City of Portland, Maine – Building or Use Permit Application 389 Congress Street, 04101, Tel: (207) 874-8703, FAX: 874-8716

Location of Construction: 34 Eastfield Rd (Lot #8)		Owner: Nigginbottom, Gary & Clara		Phone: 775-7147		Permit No: 961215	
Owner Address: 2 Bayview Terr Pctd, ME 04103		Leasee/Buyer's Name:		Phone:		BusinessName:	
Contractor Name: John Chase Chase Custom Homes & Finishing		Address:		Phone: 839-2722		Permit Issued: DEC 12 1996 CITY OF PORTLAND	
Past Use: Vacant Land		Proposed Use: Single Family		COST OF WORK: \$ 45,000.00		PERMIT FEE: \$ 745.00	
Proposed Project Description: Construct Single Family Dwelling w/attached Garage		FIRE DEPT. <input type="checkbox"/> Approved <input type="checkbox"/> Denied		INSPECTION: Use Group R3 Type: 5 BOCARE		Zone: R-3 CBL: 194-C-056	
		Signature:		Signature:		Zoning Approval: 12-8 12/12/96	
		PEDESTRIAN ACTIVITIES DISTRICT (P.A.D.) Action: Approved <input type="checkbox"/> Approved with Conditions: <input type="checkbox"/> Denied <input type="checkbox"/>		Signature:		Date:

Proposed Use/Work - New single family home with attached garage

BUILDING PERMIT REPORT

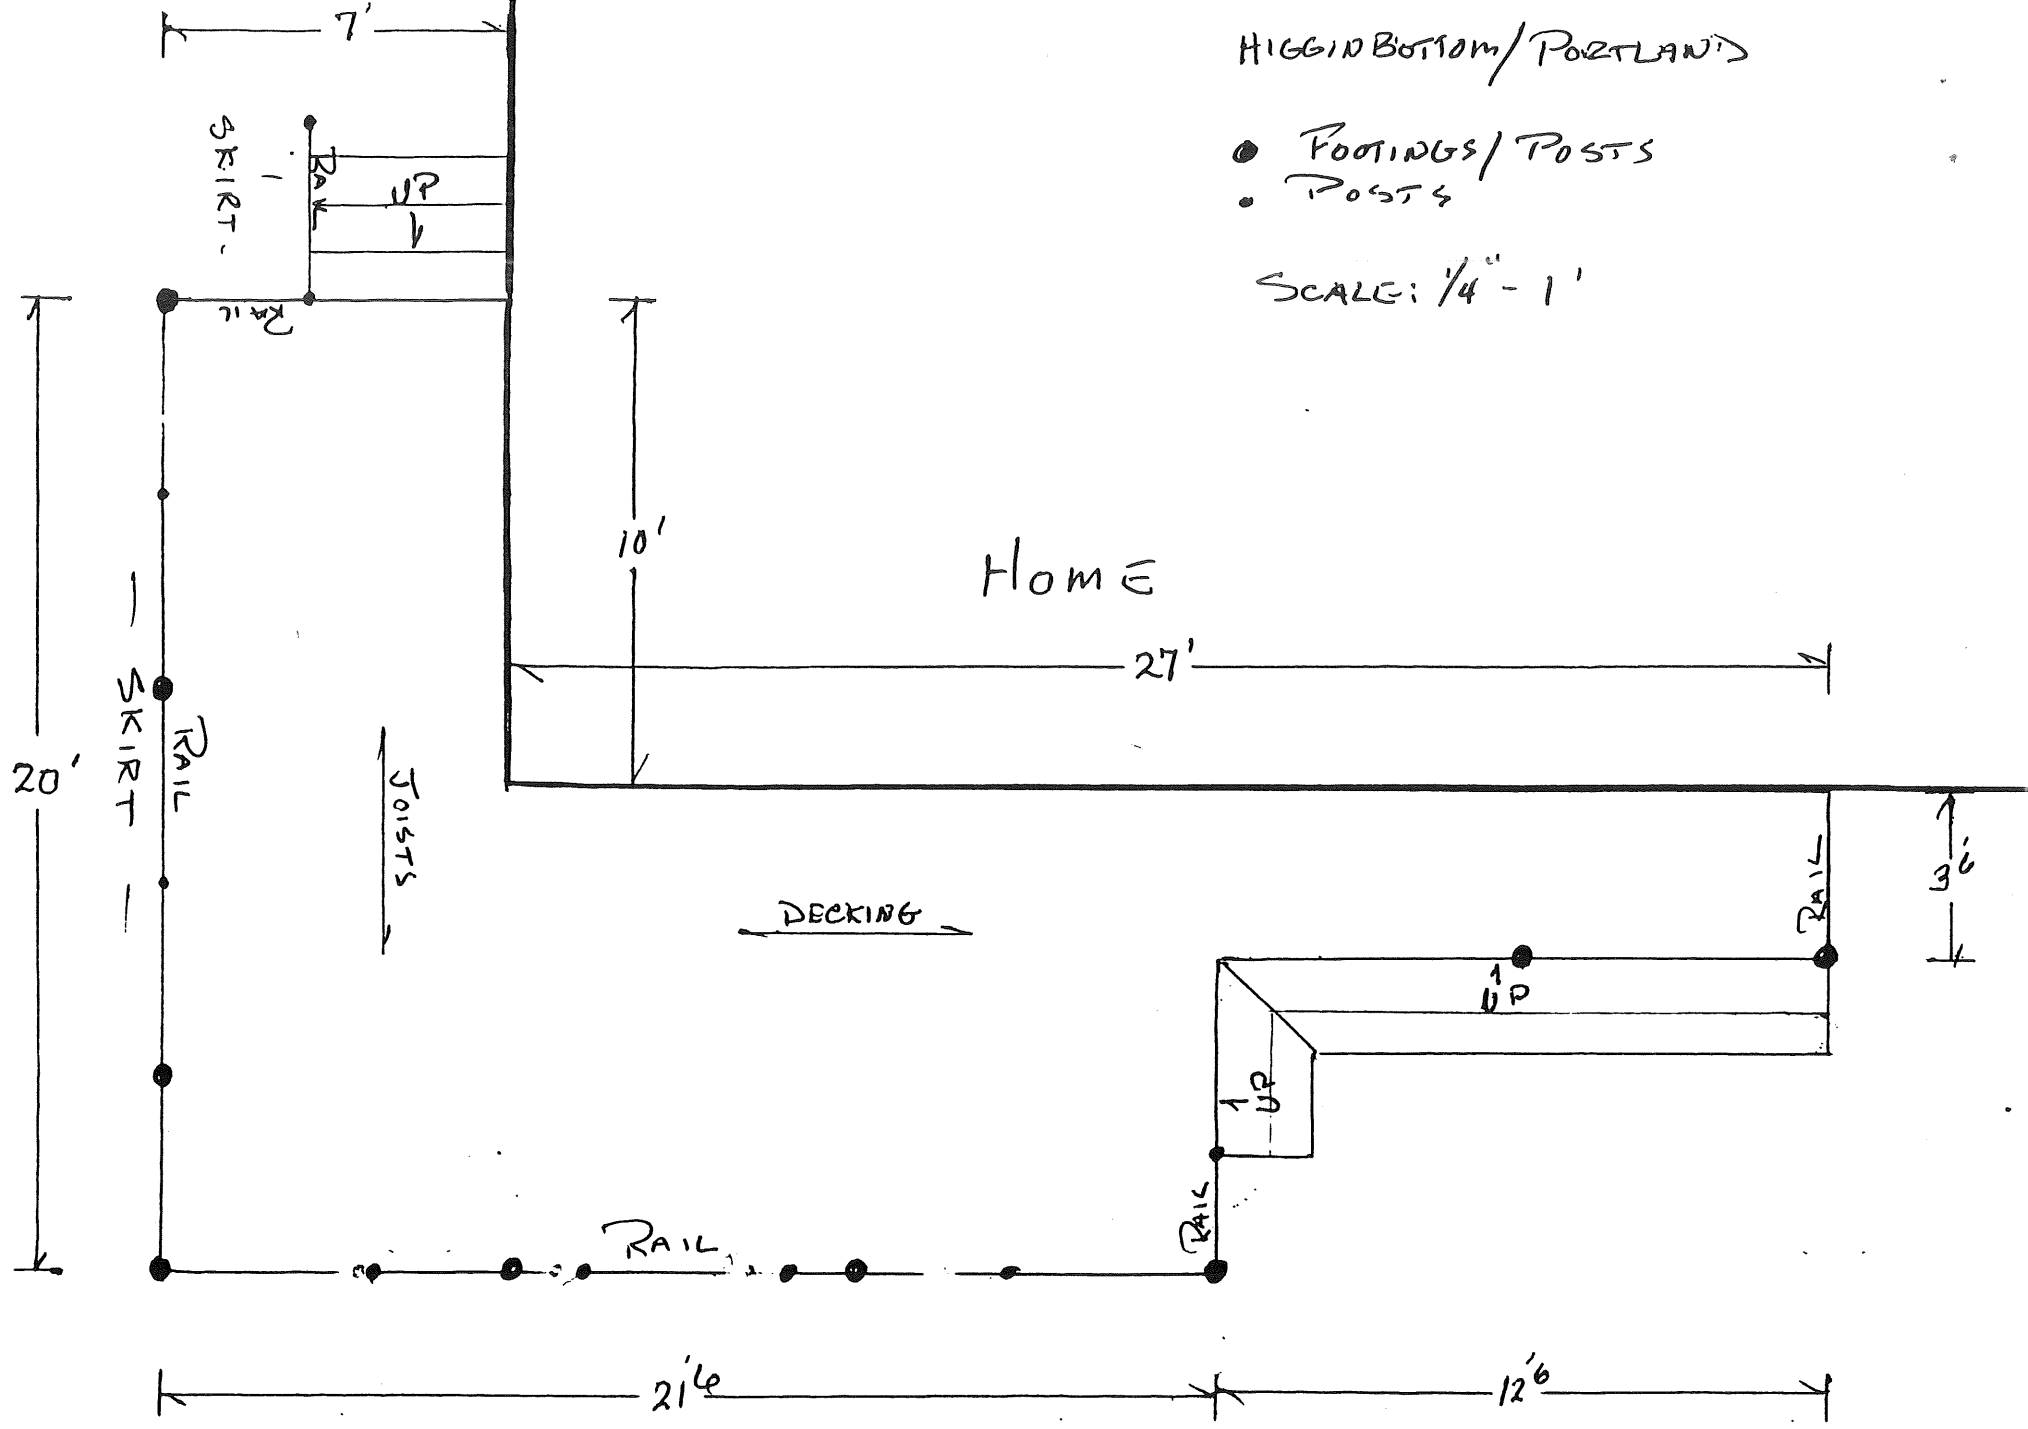
28. Your plan doesn't show any construction detail, Please
submit this ~~for~~ before work begins.
